ITS CORPORATION					REV	ECN	DATE	APV
THIS PRINT IS THE PROPERTY OF ITS CORP. IT SHALL NOT BE COPIED WITHOUT PERMISSION.					TITLE			
MATERIAL					BLOCK DIAGRAM 600W TRAY (1227-1300)			
FINISH					DWN	RFB	5/5/94	DWG. NO.
					CHK	DWR	5/5/94	1227-3300
					REL	DWR	5/5/94	4
					SCALE--- SHEET 1 OF 1

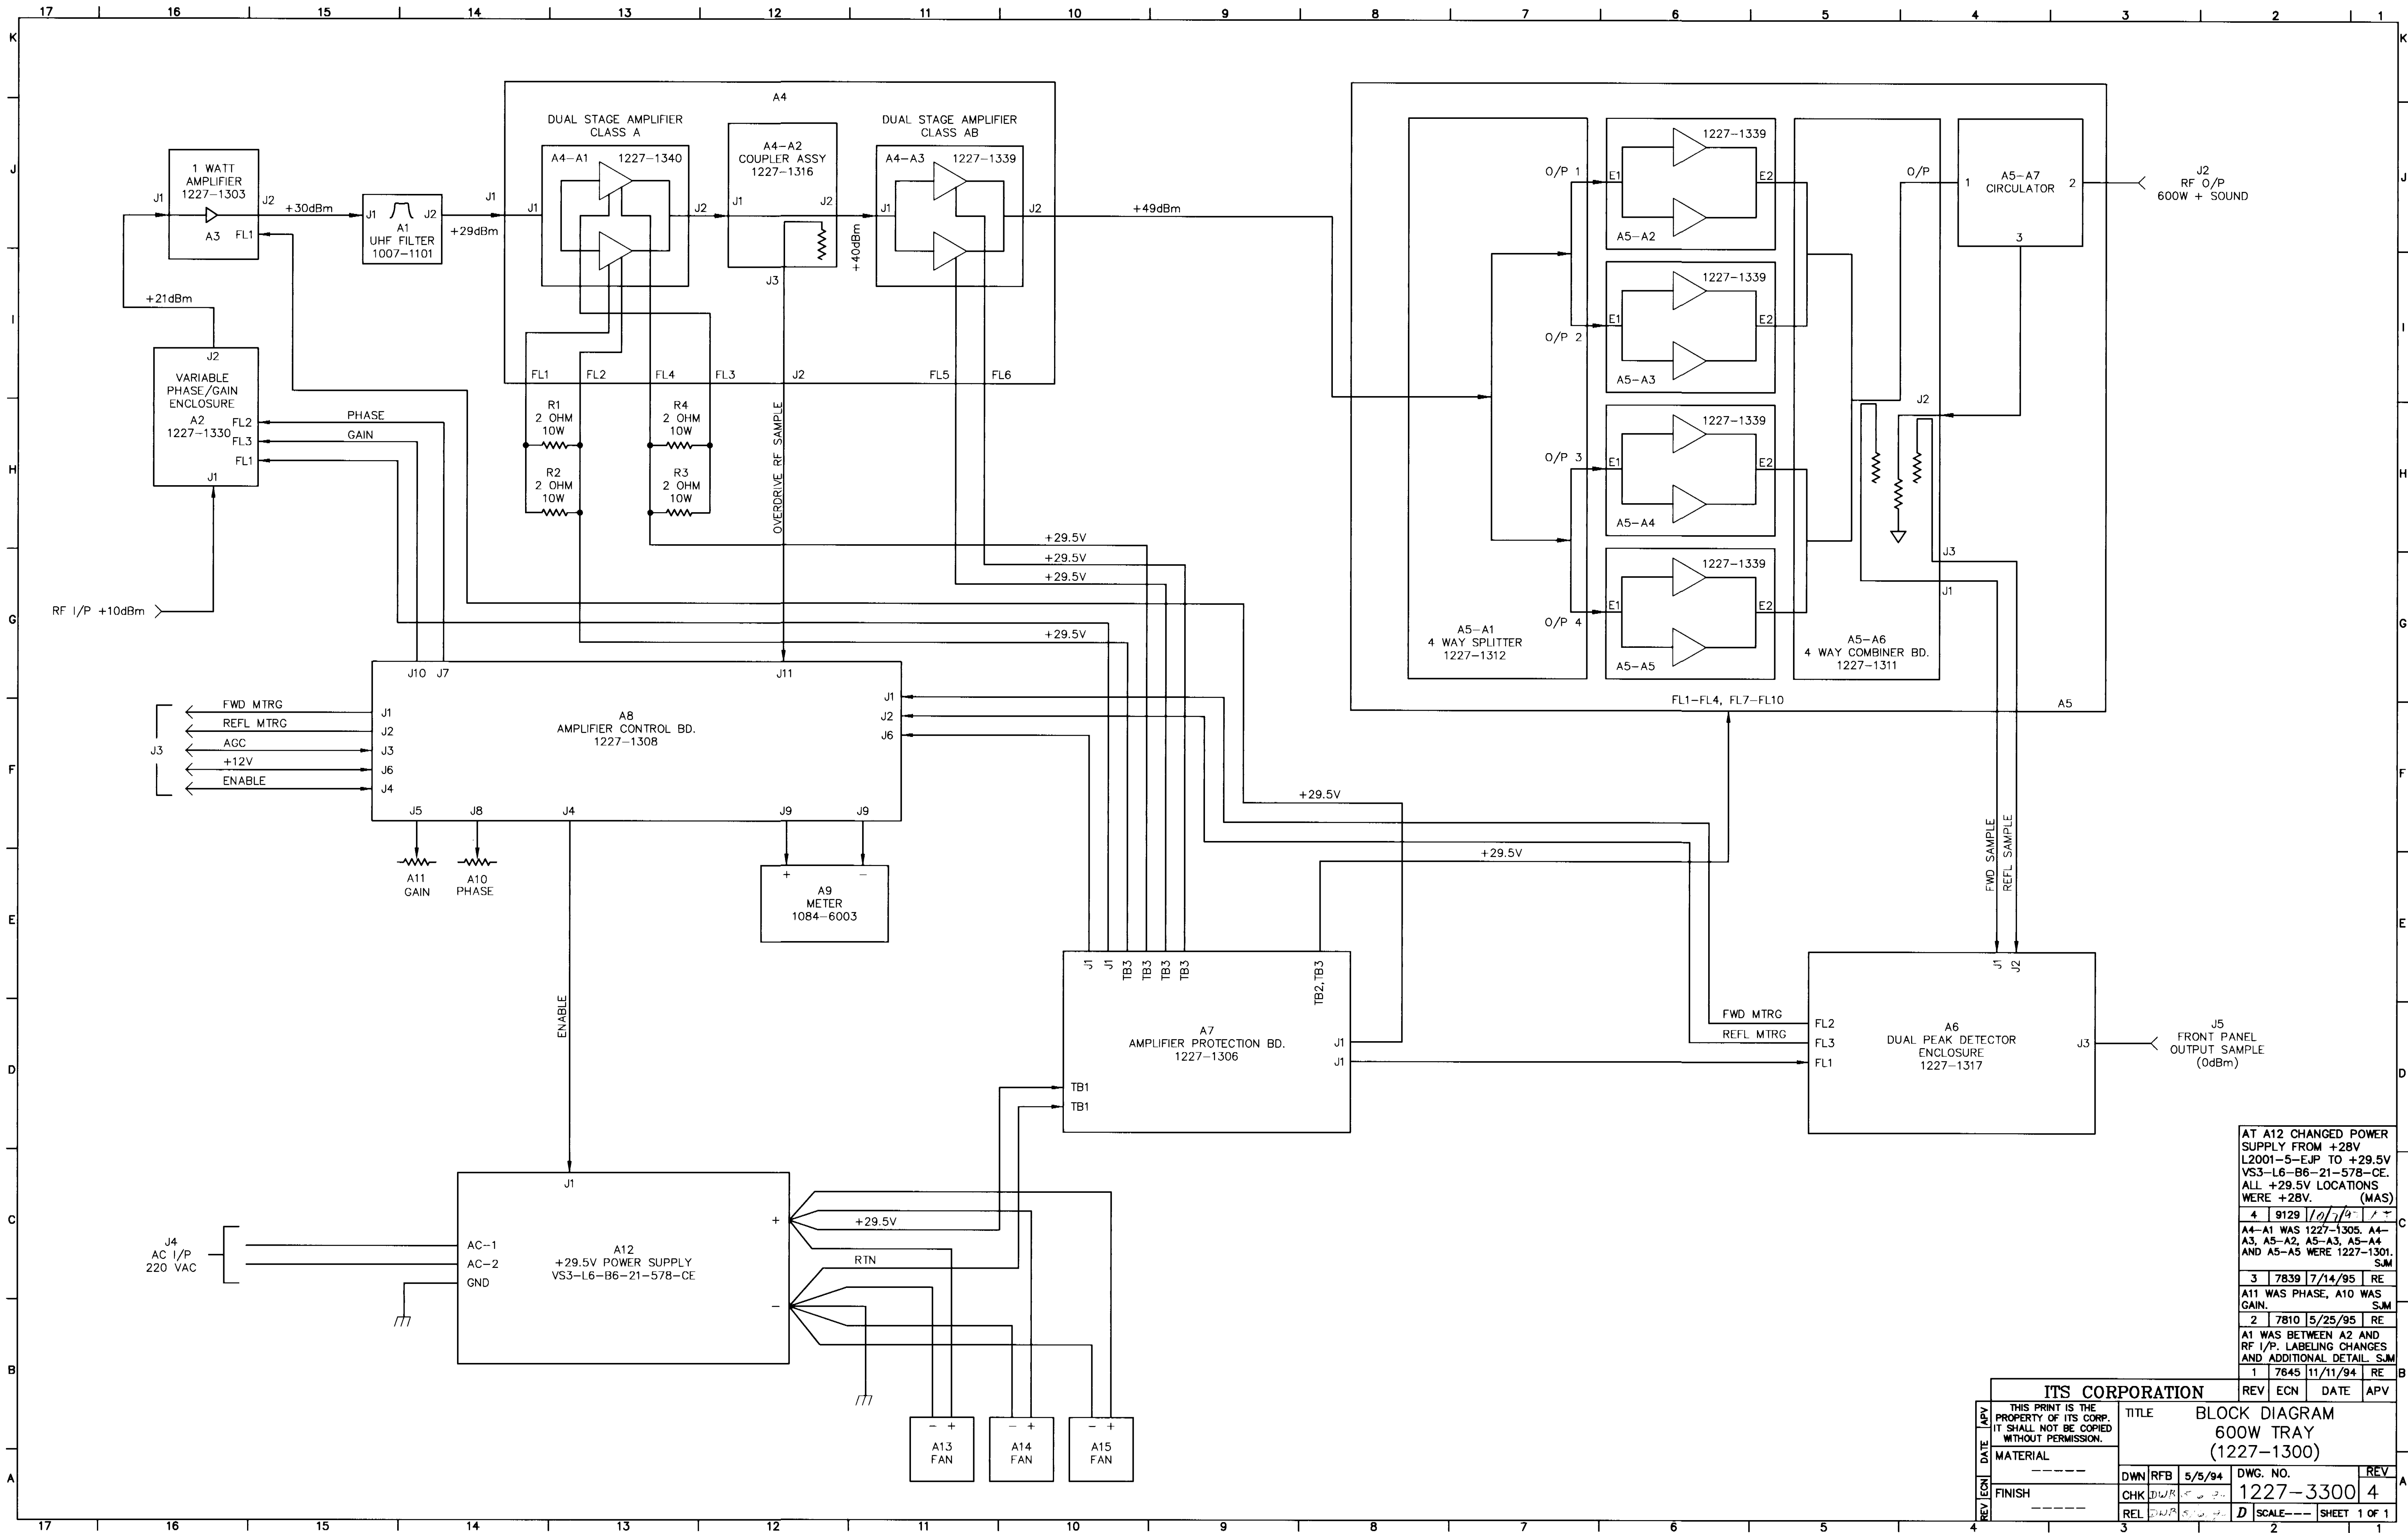
AT A12 CHANGED POWER SUPPLY FROM +28V L2001-5-EJP TO +29.5V VS3-L6-B6-21-578-CE. ALL +29.5V LOCATIONS WERE +28V. (MAS)

4	9129	1/2/79	1	+
3	7839	7/14/95	RE	
A11 WAS PHASE, A10 WAS GAIN.				
2	7810	5/25/95	RE	
A1 WAS BETWEEN A2 AND RF I/P. LABELING CHANGES AND ADDITIONAL DETAIL. S.M.				
1	7645	11/11/94	RE
